Minutes of SPIRE CQM BDA Kevlar Failure Non-Conformance Review Board

1 October 2007

8.2 Herschel-Planck/SPIRE CQM BDA Kevlar Failure Report, Mark Weilert

Figure 2: Unpolished pulley as used on CQM BDA. Note possible sharp edge on hexagonal face.

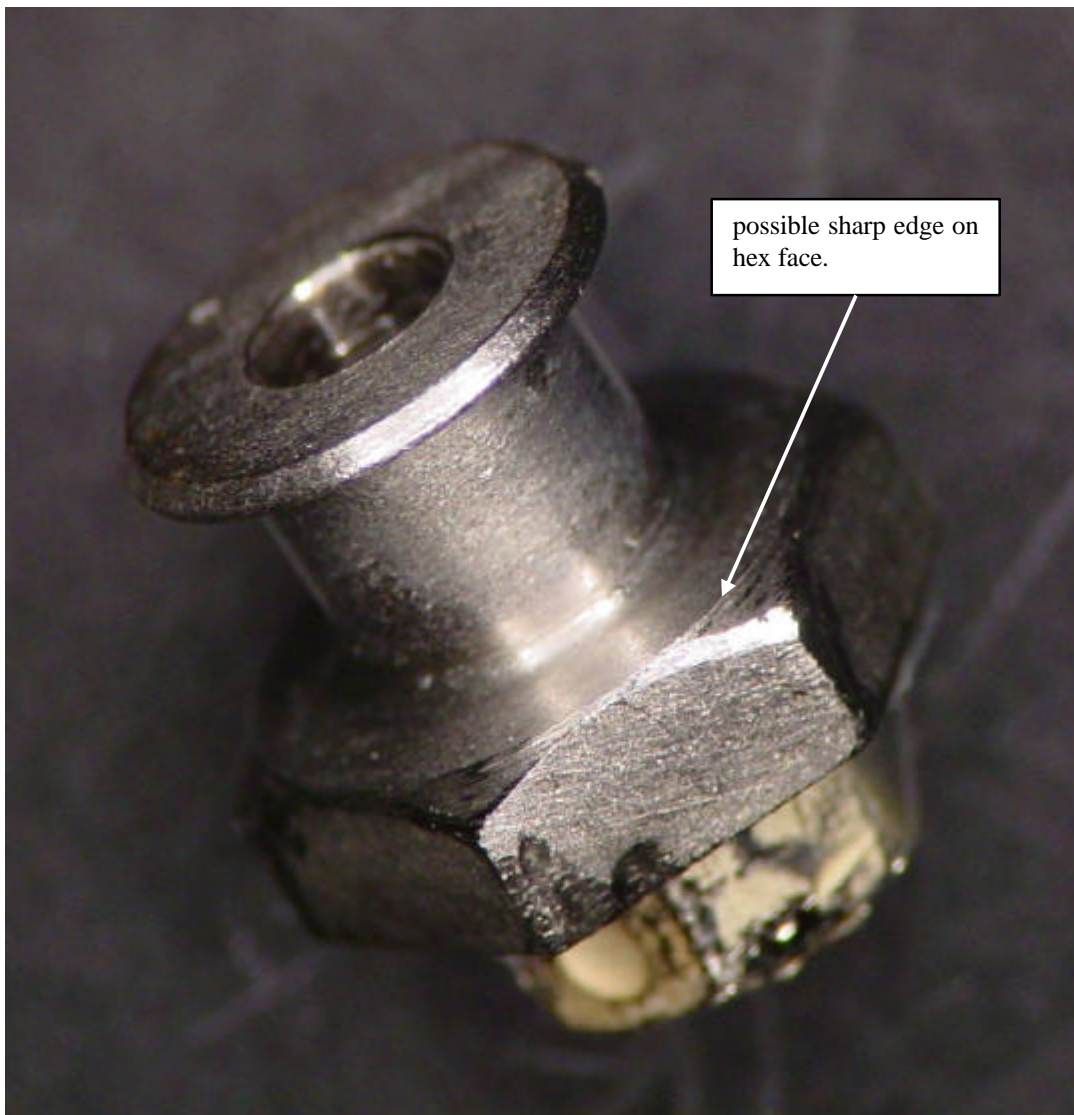
- Comments and points made during Mark's presentation.
- The CQM unit had been inspected carefully after known fraying; bottom braid had been in good shape at that stage
- Marty: Note that CQM was designated as non-flight.
- Slide 3: Note solid touch of 300-mK assembly to 2-K stage is apparent.
- Slide 4: Pete: Kevlar looks like it comes off at a slight angle, so looks like its in strong contact with the hex face.
- Slide 5: The kind of abrasion that's seen here is not very apparent until the Kevlar is removed
- Slide 6: Green areas correspond to Kevlar fluorescence signature
- Kevlar broke very close to where it came of the hex face
- Slides 8/9: CQM vs. other units
 - Key hardware differences

- Pulley design changed for qual. and all subsequent units - polished everywhere the Kevlar touches (barrel and hex face) and rounded on the hex face
 - Kevlar routing changed on the QM and flight BDAs – but on the top braid only

- Polishing was finished carefully by hand; included rounding off of all corners and edges at the hex face
- Slide 14: UV-illuminated pictures of Kevlar residue after 30-minutes vibration

Figure 8 Close-up of light-baffle end of central hub, showing failed Kevlar section

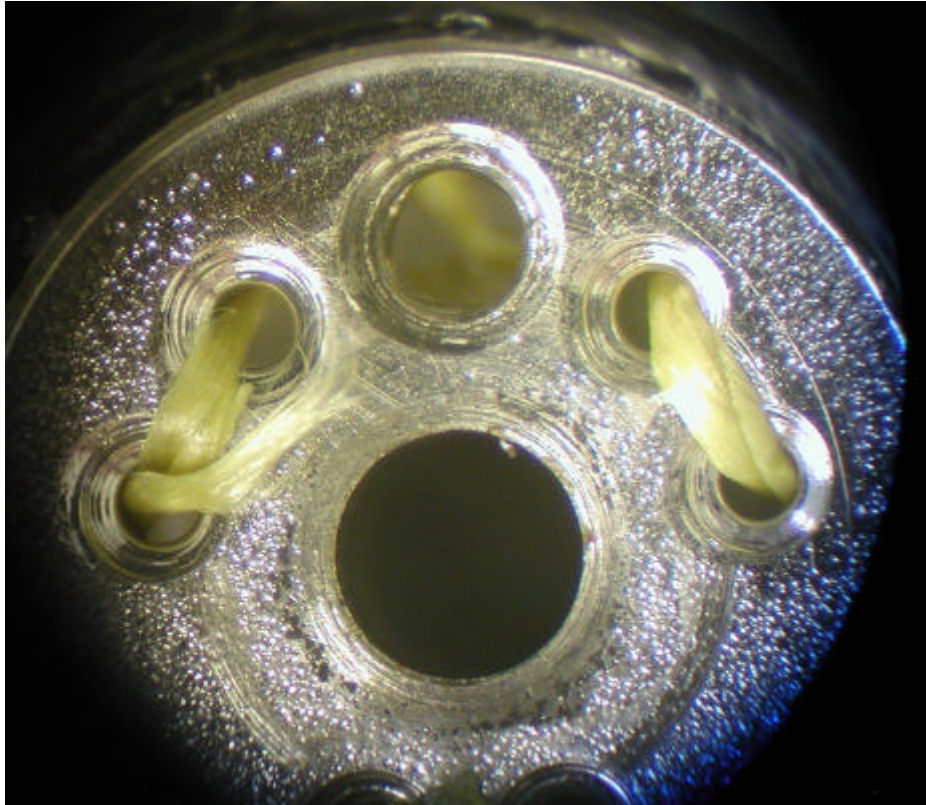
- Inspection report
 - Partial failure of a Kevlar cord – led to overall extension of the Kevlar suspension and loss of alignment
 - Page 7, Figure 8:
 - Shows poor machining quality on the guide holes

- One and a half of the three bundles broken
 - Figure 9 shows a similar phenomenon happening to another braid at the machining edge
 - Marty question: What was pre-tension?

Figure 10 View of inner hub, showing signs of mild Kevlar abrasion

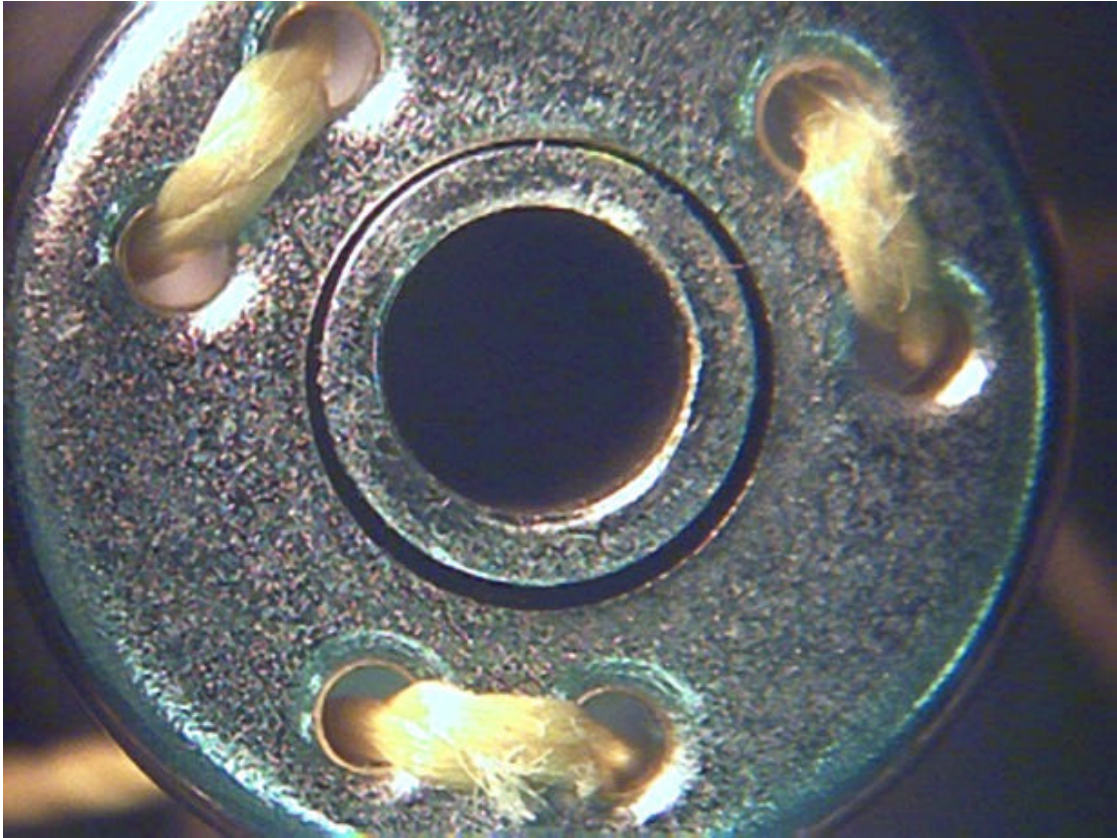
- Pete will check (but load is lower than for BDAs)
 - Figure 10
 - Fretting at the other end, but no evidence of cutting – holes were much smoother
 - Figures 11 and 12: Design shape for guide holes and as manufactured with flat top leading to sharp edge
